RESPONSE TO REQUEST FOR COMMENTS

CASE/APP NUMBER: SPR-ADJ-DAP-DR22-24

PROPERTY LOCATION: 5205 Battle Creek Rd SE, Salem OR 97306

COMMENTS FROM: Jolynn Franke, Transit Planner I, Cherriots

BUS STOP PADS LAYOUT

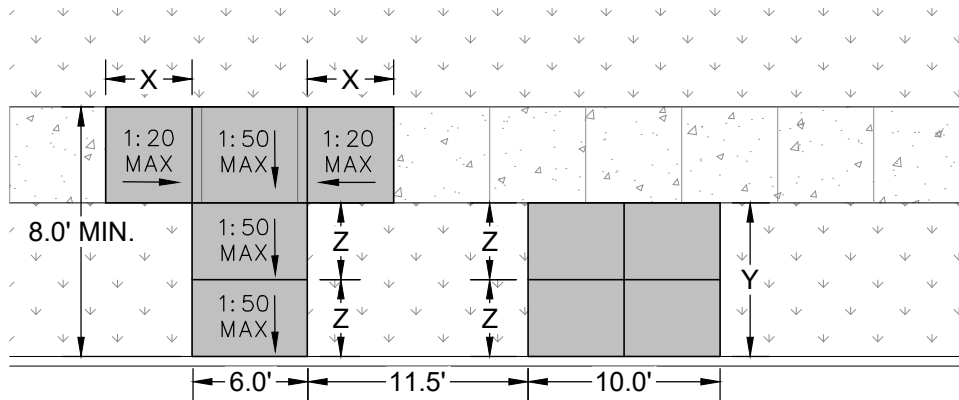
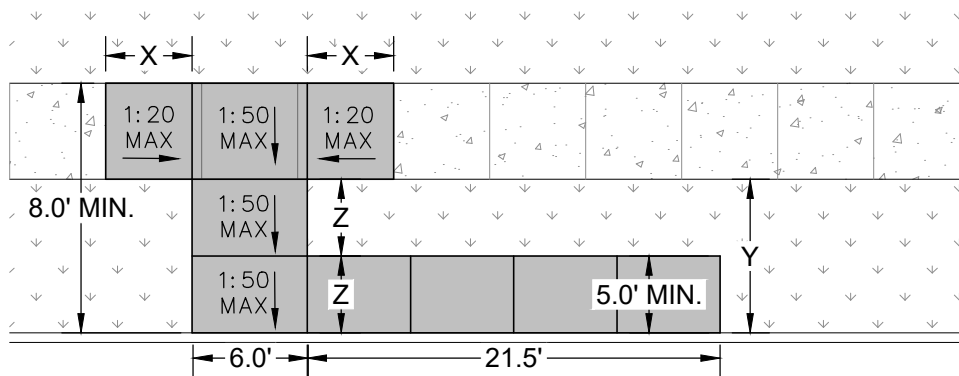
COMMENTS: Transit stops have been identified as needed in connection with this proposed development. Cherriots requests two transit stops conforming to the applicable standards of the Salem Area Mass Transit District to be constructed and right-of-way dedication, if necessary, to be provided as part of the street improvements for this development. On-street parking shall be restricted in the areas of the transit stops in order to ensure unobstructed access by transit. The transit stops should be located on Battle Creek Rd SE at the intersection with Eastlake Dr SE, far-side of the pedestrian crossing in both directions. Approximate locations are marked in the screenshot on the following page. The southbound stop should be a minimum of 50 feet away from the crosswalk. Cherriots recommends extending the curb bulb design depicted in the drawings to match the length of the median in order to accommodate the stop. The northbound stop should be a minimum of 50 feet away from the Eastlake Dr SE intersection (measured from the tangent of the intersecting street). Per our conversation with Public Works, bus pullouts are not requested for these stops. Also included in the following pages are Cherriots standard bus stop and no-parking zone design drawings.

Approximate transit stop locations requested:
